RENESAS TECHNICAL UPDATE

Product Category	MPU&MCU		Document No.	TN-MC*-A013A/E	Rev.	1.00
Title	Notes on WAIT function of the I ² C bus interface		Information Category	Technical Notification		
Applicable Product	H8/3664 group H8S/2148 group, H8S/2138 group H8S/2149, H8S/2169 group H8S/2140B group H8S/2110B H8S/2111B H8S/2114 group H8S/2128 group H8S/2158 group H8S/2168 group H8S/2194 group H8S/2199R group H8S/2258, H8S/2239, H8S/2238 group H8S/2268, H8S/2264 group H8S/2633 group H8S/2638, H8S/2636 group H8S/2643 group SH7144 group, SH7145 group	Lot No.	Reference Document	H8/3664 series	Rev.5.00	
		All		H8S/2148 series Rev.3.00 H8S/2138 series Rev.3.00 H8S/2149,69 series Rev.2.00 H8S/2140B series Rev.2.00 H8S/2110B Rev.1.00 H8S/2111B Rev.1.00 H8S/2114 group Rev.2.00 H8S/2128 series Rev.3.00 H8S/2158 series Rev.2.00 H8S/2168 group Rev.3.00 H8S/2194 series Rev.2.00 H8S/2199R series Rev.1.00 H8S/2258,39,38,37,27 series Rev.4.00 H8S/2268,64 group Rev.3.00 H8S/2633 group Rev.5.00 H8S/2636,38,39,30 group Rev.6.00 H8S/2643 series Rev.3.00 SH7144, SH7145 group Rev.3.00

Figure 1. IRIC flag clear timing on WAIT operation

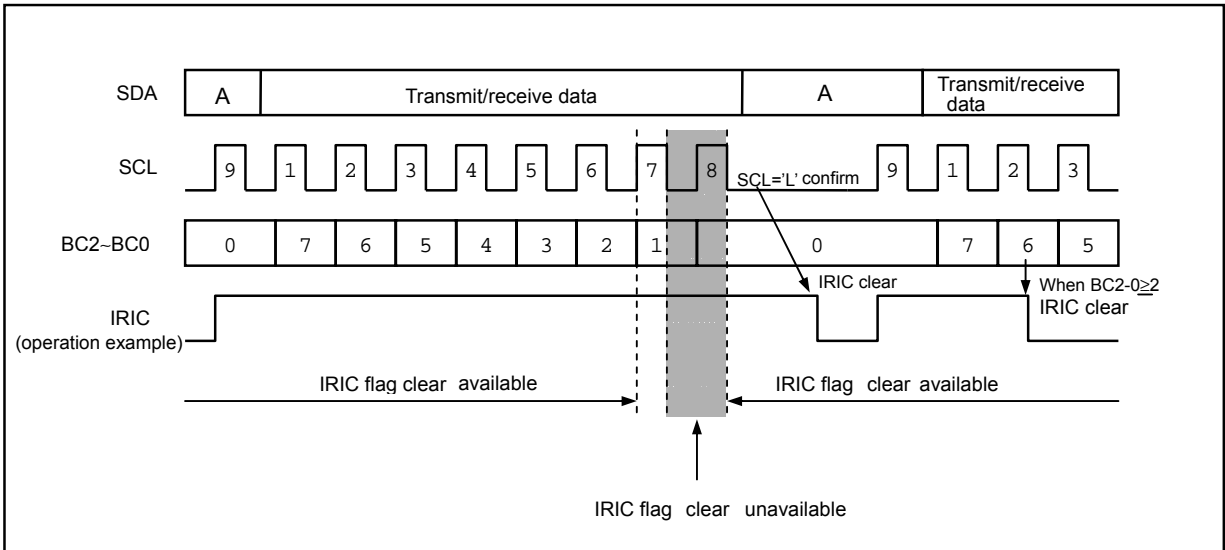
When both of the following conditions are satisfied, the clock pulse of the 9th clock could be outputted continuously in master mode using the WAIT function due to the failure of the WAIT insertion after the 8th clock fall.

- (1) Setting the WAIT bit of the ICMR register to 1 and operating WAIT, in master mode
- (2) If the IRIC bit of interrupt flag is cleared from 1 to 0 between the fall of the 7th clock and the fall of the 8th clock.

In this case, if the IRIC flag bit is cleared between the 7th clock fall and the 8th clock fall, the IRIC flag clear- data will be retained internally. Therefore, the WAIT State will be cancelled right after WAIT insertion on 8th clock fall.

Please clear the IRIC flag before the rise of the 7th clock (the counter value of BC2 through BC0 should be 2 or greater), after the IRIC flag is set to 1 on the rise of the 9th clock.

If the IRIC flag-clear is delayed due to the interrupt or other processes and the value of BC counter is turned to 1 or 0, please confirm the SCL pins are in L' state after the counter value of BC2 through BC0 is turned to 0, and clear the IRIC flag. (See Figure 1)
